# BCA/NCC Compliance assessment of the Existing 2 Storey Building at 75 Bridge St Muswellbrook NSW

Location: 75 Bridge St Muswellbrook NSW

Image (a)

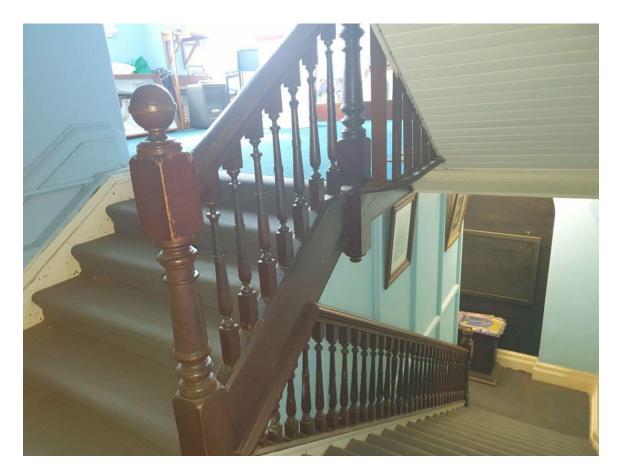
- 1. Two (2) Stairways are required to serve the upper level as 9b USE
- 2. The raised section of floor is considered a stair and requires handrail, nosings and the like as it contains 2 risers Image (h)
- 3. Internal Stair had some inconsistent risers in terms of dimensions and differences between some risers and other risers Image (a) and (e)
- 4. Handrail dimensions and geometry did not comply in terms of gripping and usability (a 38mm or similar) round rail is required with nothing that will break the handhold for length of rail. Image (a) and (d)
- 5. Balustrade (Barrier) on flight of stairs was less than 865mm above stair nosings which does not comply with BCA Image (a)
- 6. Handrails are not continuous through the flights Image (a)
- 7. There are doorways that open directly onto stairways which is not compliant with the BCA (A landing is required) Image (c)

Image (b)

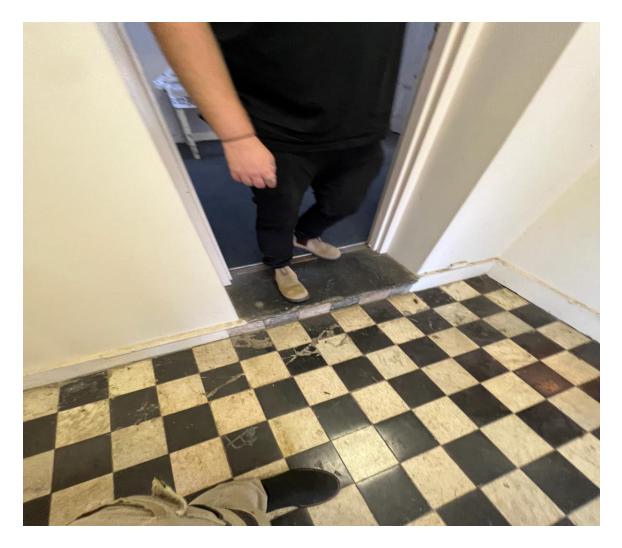
- 8. There is a step located at doorway threshold which is not compliant with the BCA Image (b)
- 9. There is non compliant head clearance above riser on exit stair (2m required) Image (f)

Image (e)

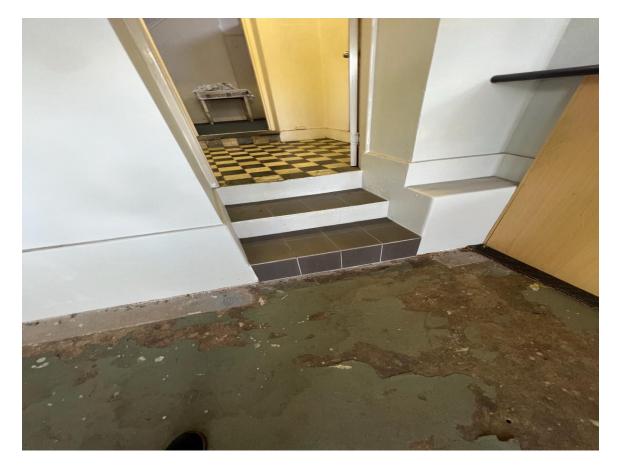
- 10. No handrail provided at stairway Image (e)
- 11. Enclosure under required stairway is not fire rated as required in BCA Image (g)
- 12. All stairs require the following under current code:
